**County of Fairfax, Virginia
Planning Commission Meeting
November 16, 2022
Planning Commission Action**

SSPA 2021-IV-3MV – HUNTINGTON METRO STATION
(Mount Vernon District)

PLANNING COMMISSION HANDOUT
Plan Amendment 2021-IV-3MV
November 16, 2022

Figure 12, Huntington Transit Development Area Height Limits (Draft Plan Text)

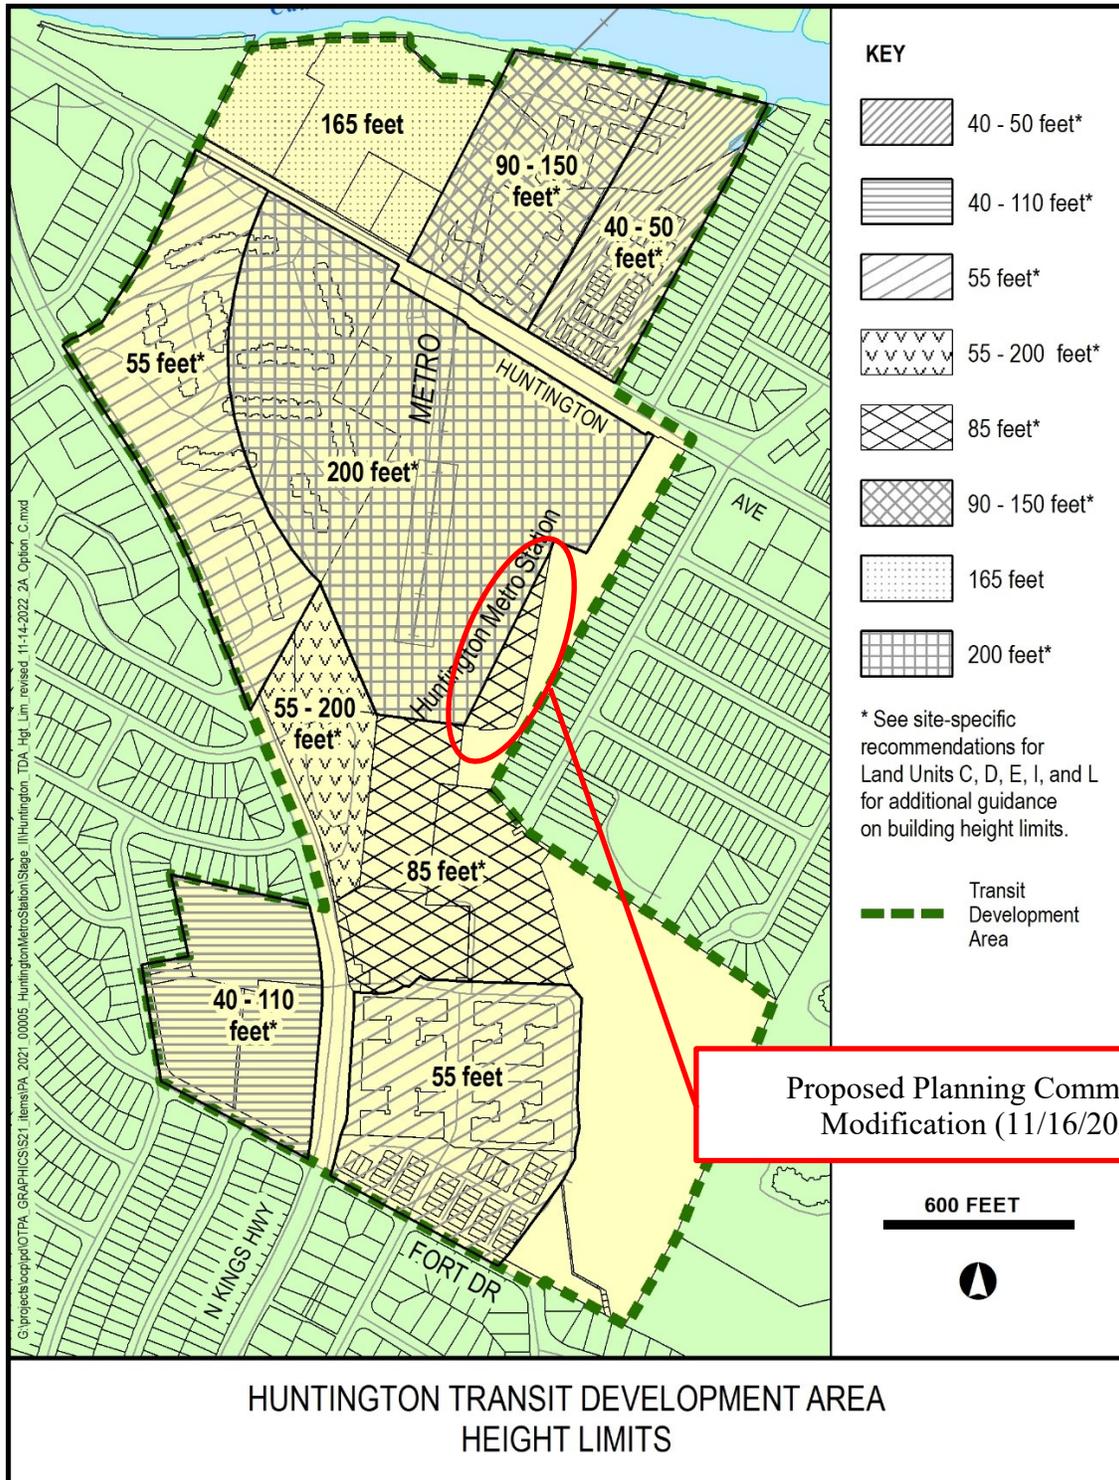
The second modification would address concerns about the building height for the Huntington community, east of the site. The modification would revise the proposed Huntington Transit Development Area Height Map to reduce the maximum building height in an area west of the landscape buffer between the middle garage and the nearby homes on Biscayne Drive. An updated map depicting the proposed Height Limits is included with this motion and shows a reduction from 200 feet to 85 feet, which will provide an appropriate transition.

Planning Commission Modification #2
